**COMMONWEALTH OF KENTUCKY
BEFORE THE PUBLIC SERVICE COMMISSION**

ELECTRONIC 2021 JOINT INTEGRATED)
RESOURCE PLAN OF LOUISVILLE GAS) CASE NO. 2021-00393
AND ELECTRIC COMPANY AND)
KENTUCKY UTILITIES COMPANY)

**JOINT INTERVENORS' INITIAL COMMENT ON LOUISVILLE GAS AND
ELECTRIC COMPANY AND KENTUCKY UTILITIES COMPANY'S
JOINT 2021 INTEGRATED RESOURCE PLAN**

Report on Louisville Gas and Electric Company and Kentucky Utilities' 2021 Integrated Resource Plan

Figure 1. The Companies’ Modeling Process

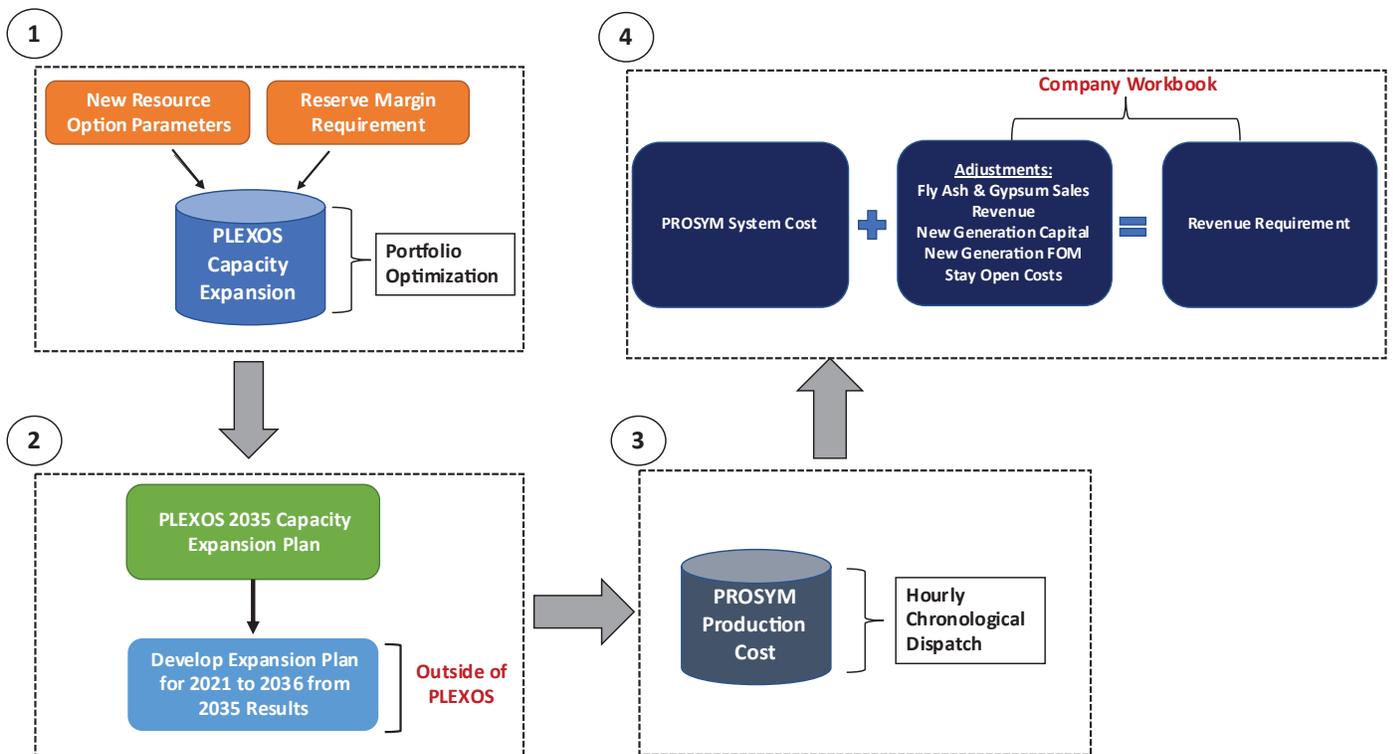
We have serious concerns about the Companies’ modeling approach for this IRP. Figure 2 depicts the modeling process that we usually see utilized by utilities using PLEXOS for IRP modeling.

It is more traditional for utilities to leverage the same software for the capacity expansion and production cost modeling steps and not break these two steps out into two different models. For example, the three primary electric system models we see used in IRPs, EnCompass, Aurora, and PLEXOS, all have the capability to perform capacity expansion and production cost modeling. There are a variety of reasons for the use of one model, the first being that it's more cost-efficient to do so, as only one license fee has to be paid. Another is that it reduces the opportunity for errors. While these models typically require similar types of information, they have different formatting requirements, so there is room for additional errors in translating the data from one model into the format required for another model. A third reason is that using one model saves time. It's much easier to launch a production costing run immediately after the capacity expansion run if the same model is used. In fact, at least one of these models can be scripted to do that automatically. Finally, there isn't such a huge differential in tool capabilities that it would make sense in most circumstances to use one of these tools for capacity expansion modeling and another for production cost modeling. There may be reasons to use two modeling tools when there are additional purposes in mind, e.g., a resource adequacy or reserve margin study, because tool capabilities become a more salient point. So the use of SERVIM for that purpose makes sense. But for IRP modeling purposes, it's hard to envision a reason to use more than one tool.

Figure 3. Distributed Generation Forecast Scenarios

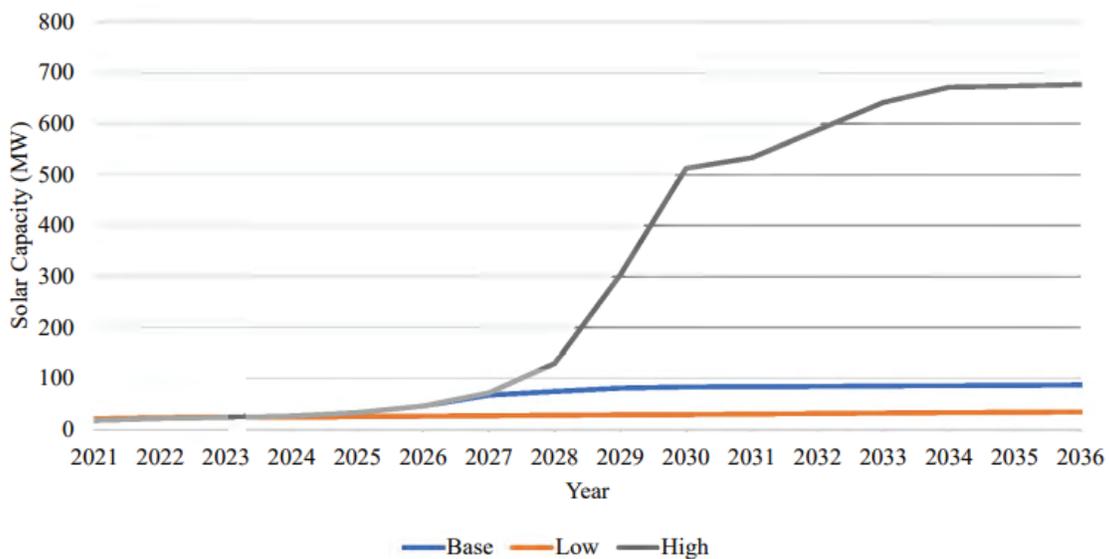
While not as frequently the subject of economic evaluation in IRPs as DSM, distributed solar may have the ability to play an important role on the Companies' system and ought to have been evaluated here. As shown in Figure 5-13 of the IRP, replicated here as Figure 3, the Companies foresee the potential for significant buildout of distributed solar. In the IRP, the Companies state that "in the high scenario, a new federal law is assumed to eliminate the 1% cap on total installed net metering capacity." However, it's important to recognize that the 1% threshold is not, in fact, a cap that limits the utilities' ability to offer net metering. The relevant Kentucky statute says, "If the cumulative generating capacity of net metering systems reaches one percent (1%) of a supplier's single hour peak load during a calendar year, the supplier **shall have no further obligation** to offer net metering to any new customer-generator at any subsequent time [emphasis added]."¹⁴ In other words, utilities have the option to continue offering net metering beyond the 1% threshold. The Companies can and should consider the value of offering additional net metering through the IRP. There are a number of tools available that would allow the Companies to create supply curves of distributed solar and their associated incentive costs. That curve can be offered to the IRP model as one of many resources to select.

The supply curve can also be tailored as dictated by the circumstances of the Companies’ system. For example, net metering is a key measure to ensure affordability for low-income customers, so the revenue requirements impacts of a program open exclusively to this group could be evaluated.

Figure 4. Scarcity Price Curve Used in Reserve Margin Study

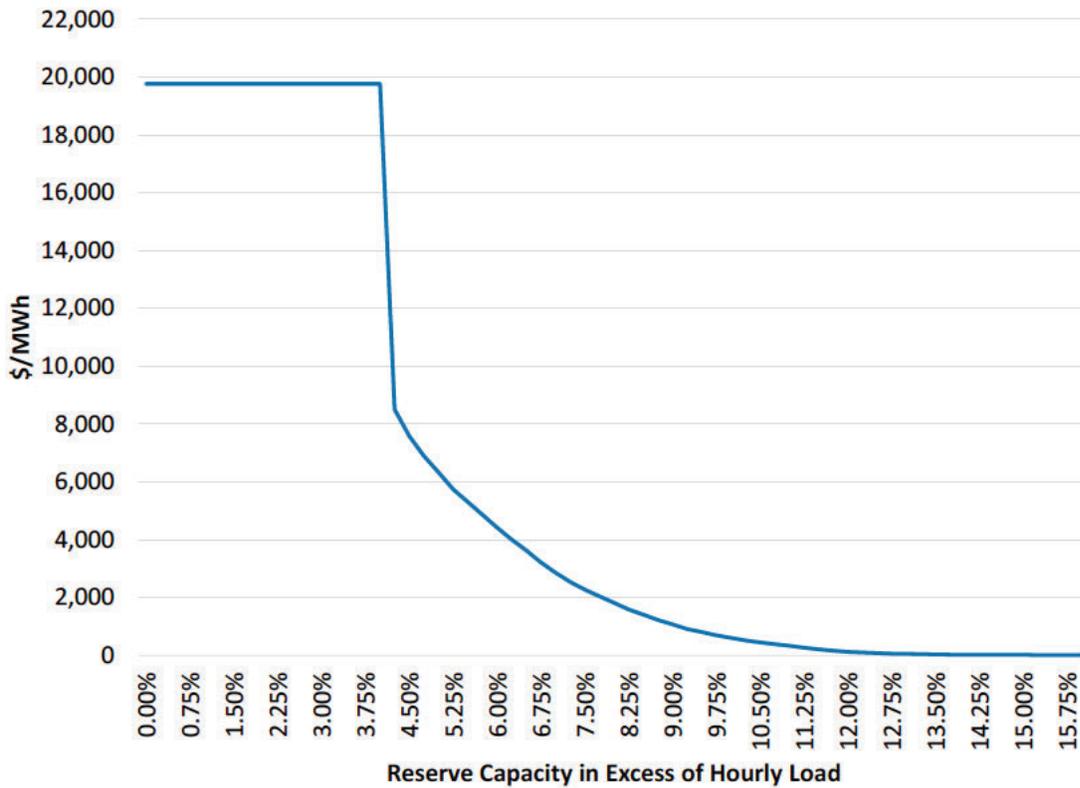
Additional improvements to the SERVM modeling would enhance the accuracy and value of these results in future analyses. For example, while it is a positive that the Companies included neighboring regions PJM, MISO, and TVA, the Companies imposed what they term “scarcity pricing” onto market interactions with those regions. The scarcity price curve is shown in Figure 4.

This graph shows that in any hour of the SERVM simulation in which the amount of capacity in excess of load falls below 15.25%, a scarcity price would be assessed on any transfers of power between a neighboring region and the Companies’ service territory (and we presume vice versa, though it’s not clear in the report or modeling files). That price grows quite rapidly from a low of \$20 per MWh to \$226 per MWh at 11.5% reserve and tops out at \$13,760 per MWh at 3.5% excess capacity or less. Indubitably, wholesale power prices rise when demand is high and generation constrained, but we’re skeptical that an increase to these levels is warranted. We examined hourly real-time pricing at the LG&E-MISO and the PJM-EKPC interfaces³² over the last four years as shown in Table 6.

Figure 5. Actual LGEE 10-minute Area Control Error (Imbalance) for 2021⁴⁷

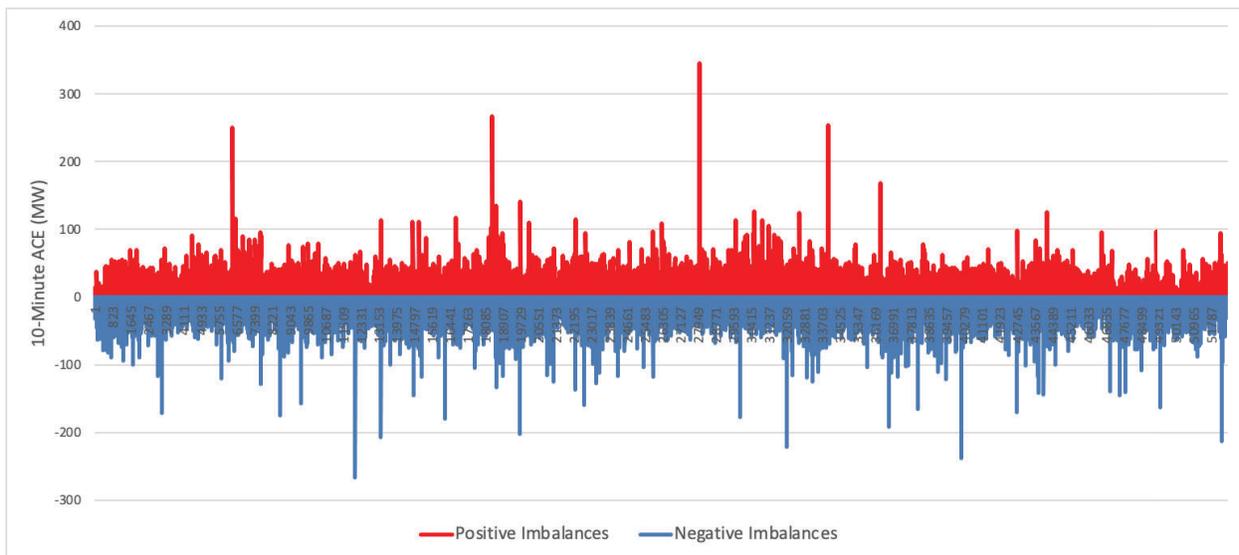
The North American Electric Reliability Corporation (“NERC”) balancing standards are assessed on a greater than 5-minute basis⁴⁶ and allow for both positive and negative excursions for specified durations before a violation would occur. Historic imbalances, known as Area Control Error (“ACE”) are recorded at 10-minute and 1-minute intervals. ACE data reported by the Companies show that positive and negative imbalances are the norm for system operations, see Figure 5, below. Note that these are not

At no point in 2021 was the Companies' system perfectly in balance on either a 10-minute or 1-minute interval. Without additional information about the rationale for the claim that there are significant imbalances with 1,000 MW of solar on the Companies' system and more information about the analysis performed, it appears that the Companies are imposing a standard on solar that they cannot meet today with the existing portfolio.
